## **Traffic Calming (Speed Humps) - Glen Park Avenue**

**Date:** November 19, 2025

**To:** North York Community Council

**From:** Director, Enforcement and Street Management, Transportation Services

Attachment 2: Speed Hump Locations Plan - Glen Park Avenue, between Danesbury Avenue and Capitol Avenue

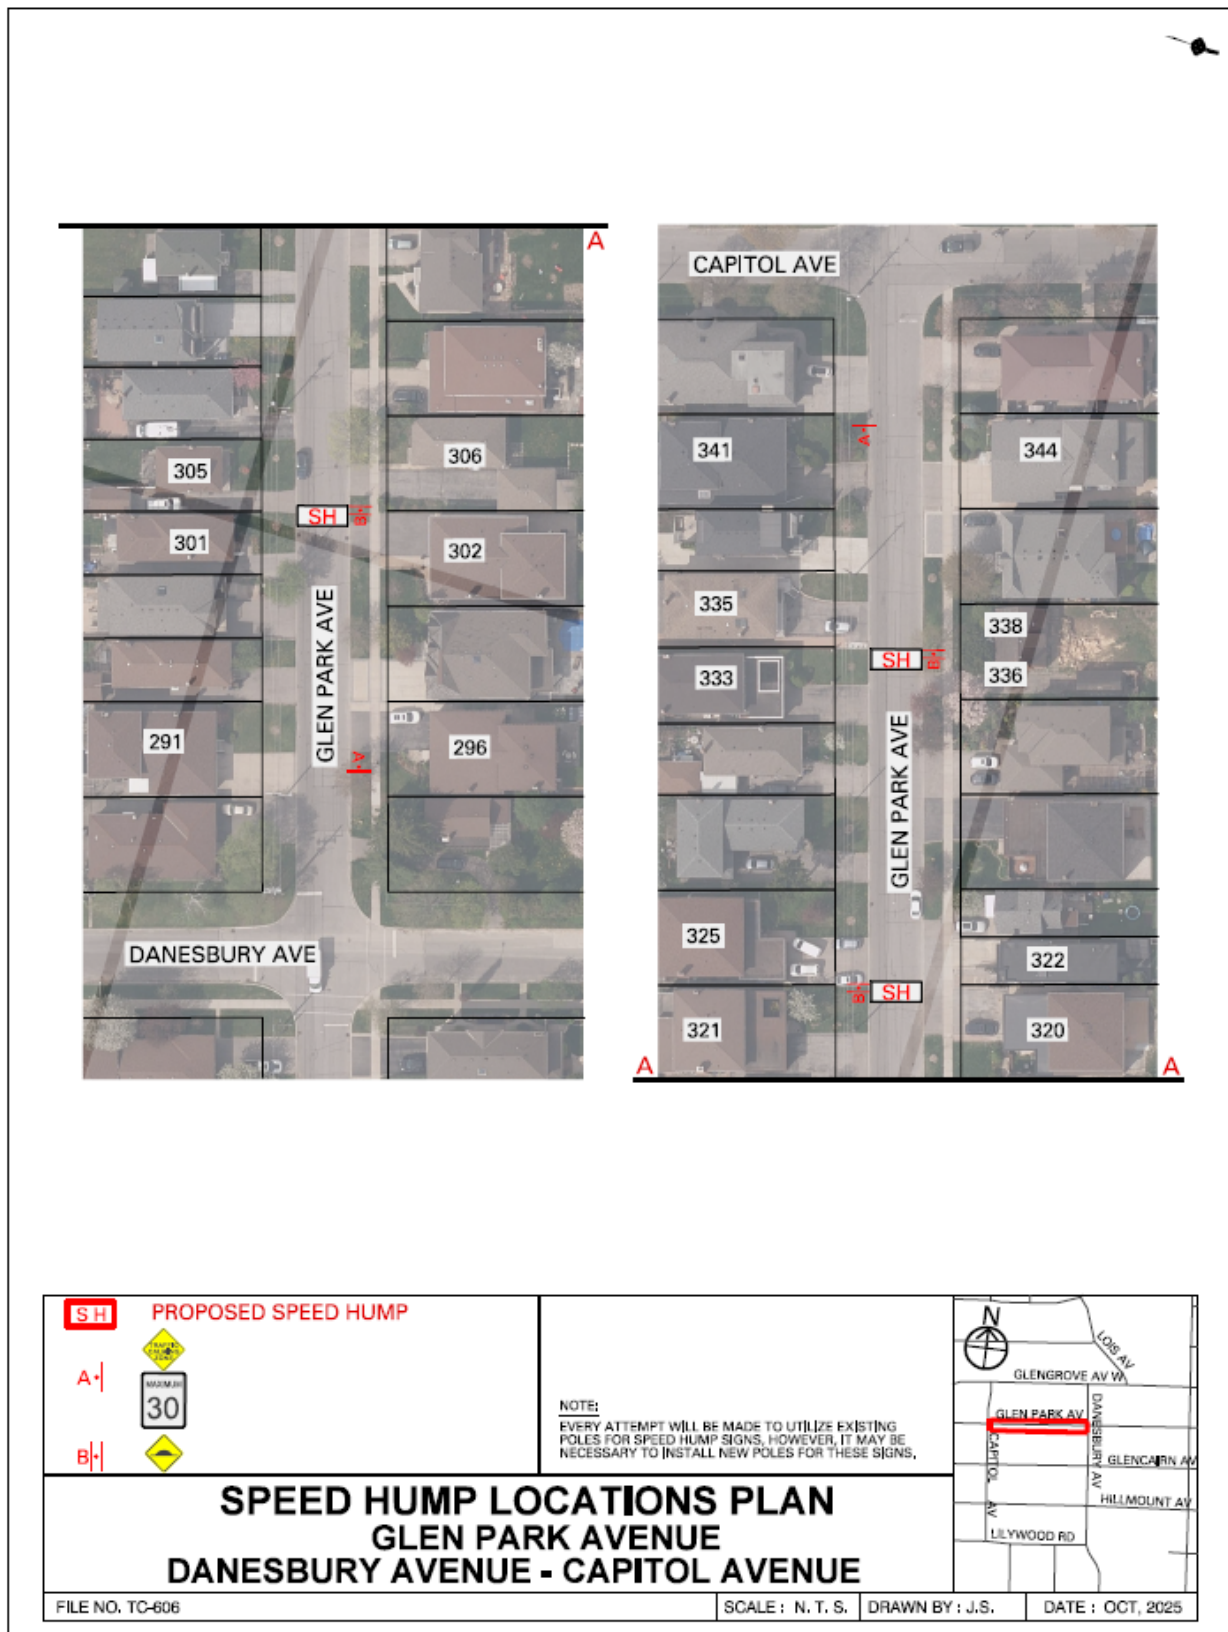
We have received and reviewed the proposal for installation of speed humps on Glen Park Avenue, between Danesbury Avenue and Capitol Avenue, with the following comments:

The installation of speed humps on Glen Park Avenue, between Danesbury Avenue and Capitol Avenue, will impact response and transport times for residents that reside on the roadway speed humps are installed. Impacts may extend to community members if Glen Park Avenue, between Danesbury Avenue and Capitol Avenue, serves access to other roadways. It is important that the applicant understands that the installation of traffic calming devices will reduce the speed that emergency vehicles travel when responding to emergencies on roadways where they are installed.

Toronto Paramedic Services is supportive of community initiatives that improve the safety of all citizens of, and visitors to, the City of Toronto. Traffic and pedestrian safety are key components of a healthy neighbourhood, and we endeavour to support the wishes of the community to implement measures to improve upon these components.
